Merton Council

Planning Applications Committee

18 June 2015

Supplementary Agenda (Modifications Sheet).

Drawing Title
LANDSCAPE MASTERPLAN

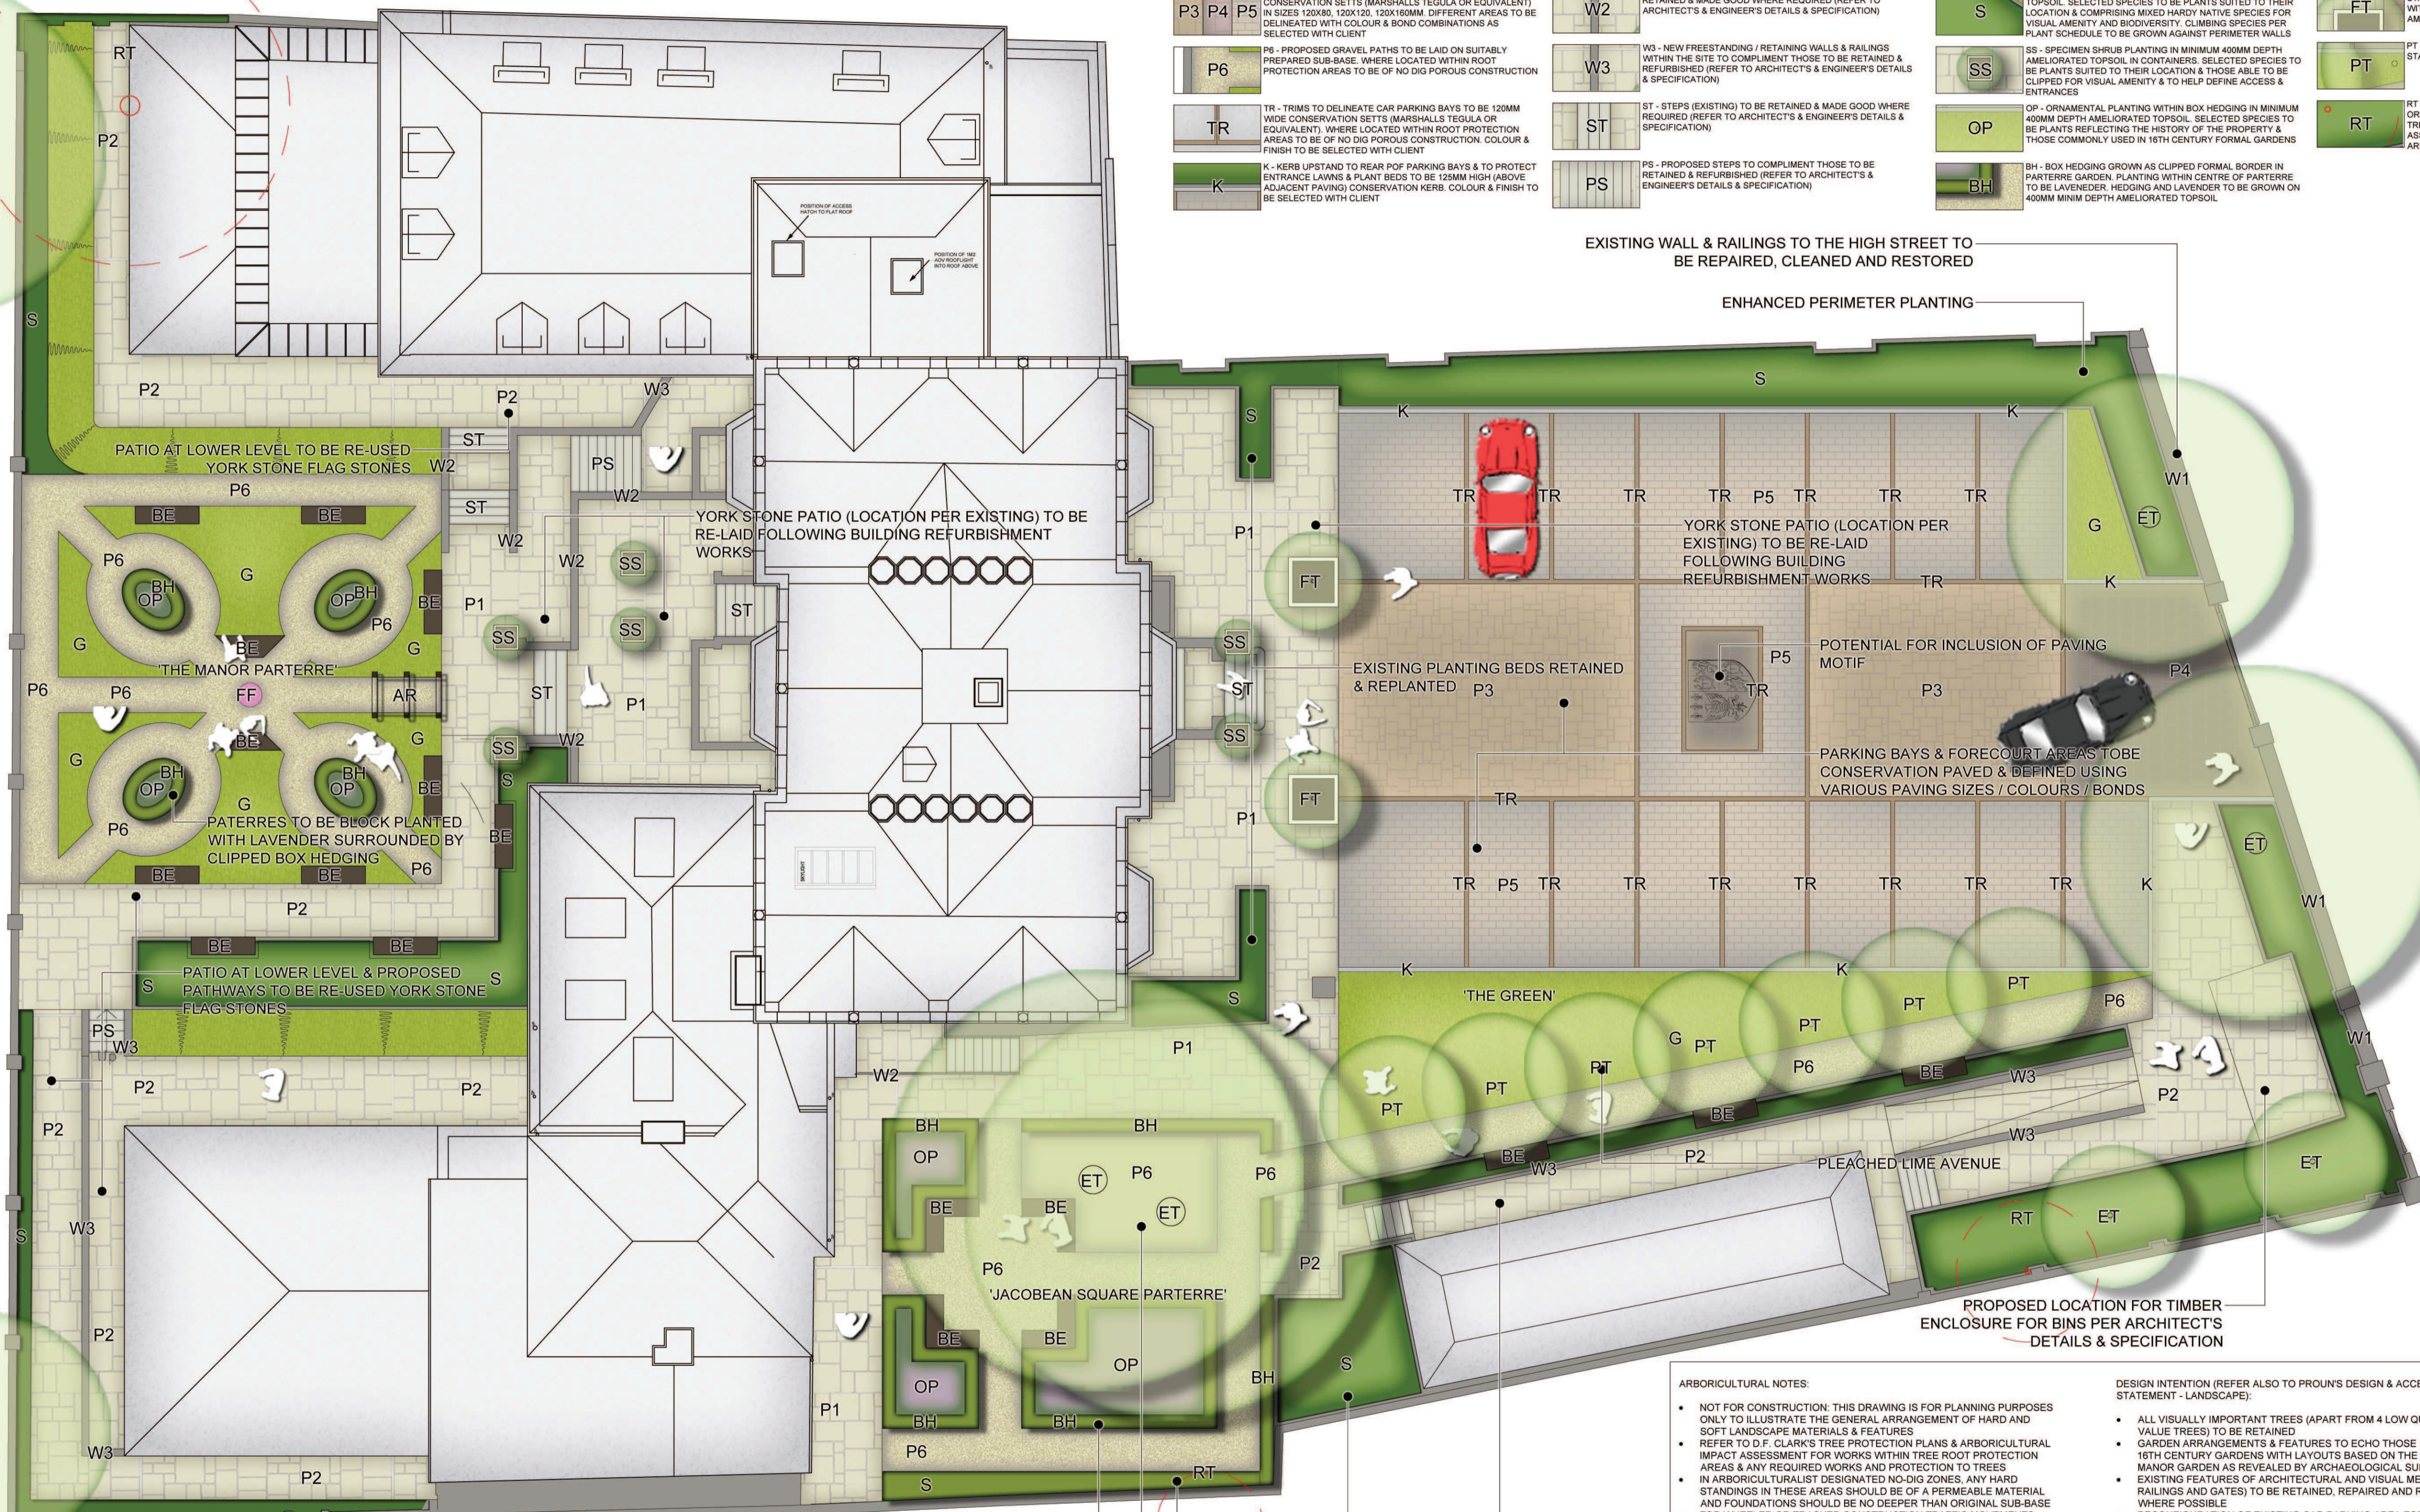
The landscape masterplan is appended.

(amended to reflect superimposition of landscape masterplan on floor plans and adjusted position of refuse store in line with landscape masterplan).
